SERVICE BULLETIN

ENGINE FUEL CONTROL BOX ATTACHMENT BOLT REPLACEMENT

All MD Helicopters, Inc. (MDHI) 600N helicopters, serial number RN003 thru RN026.

Figure 1. Engine Fuel Control Box Attachment Bolt Replacement.

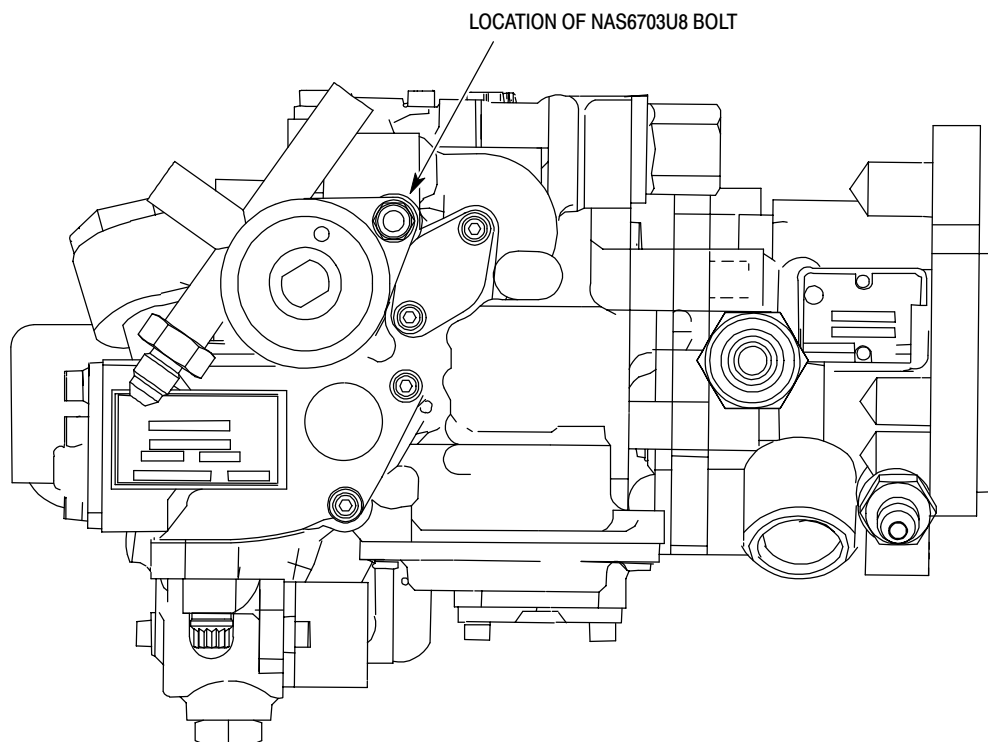
Inspection of an aircraft after a recent ground run revealed that the subject bolt had fallen out. A longer bolt will provide proper thread engagement and eliminate this from happening. Failure to comply with the requirements of this Service Bulletin may result loss of engine throttle control. This condition may result in a precautionary/emergency landing situation.

- (1). Replace NAS6703U6 bolt with NAS6703U8 bolt per instructions contained in the Handbook of Maintenance Instructions (CSP-600HMI-2/3) Section 76-00-00 (ref. to Figure 1 below). **NOTE:** This installation is also shown in the Illustrated Parts Catalog (CSP-IPC-4, Section 71-00-60, Figure 3).
- (2). Record compliance to this Service Bulletin in the Compliance Record section of the helicopter Log Book.

REPLACEMENT PARTS/SUPPLIES			
Nomenclature	Part No.	Qty.	Source
Bolt	NAS6703U8	1	MDHS
